FCC ID: YGN-RFKTBX001
Product Name: RF Controller (Model: GS, GS-W)

Request for Class II permissive change

Change Description

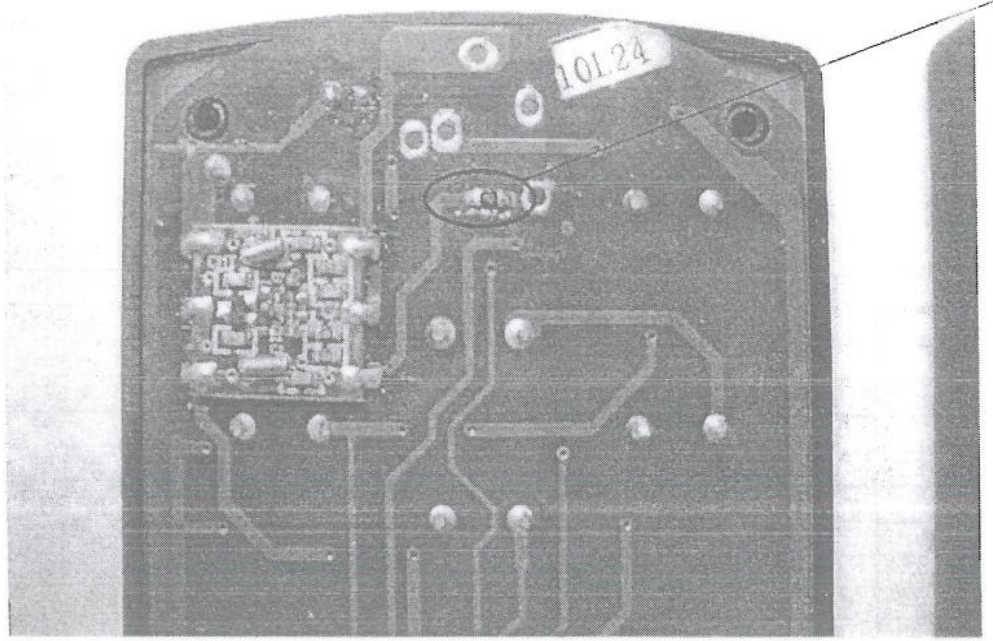
1. Hardware:
Have added 1 pc 15K current-limiting resistance to the signal input of the transmitter module to reduce the transmitting power, then the frequency can meet the requirements of FCC (the test result is in following report.) , but the range of transmitter is shorter.

2.Software:
Nothing changed.

3.Tuning:
Main frequency haven't been changed, still is 433HZ.

4.PCB layout:
Noting changed.

5.Power setting:
Noting changed.
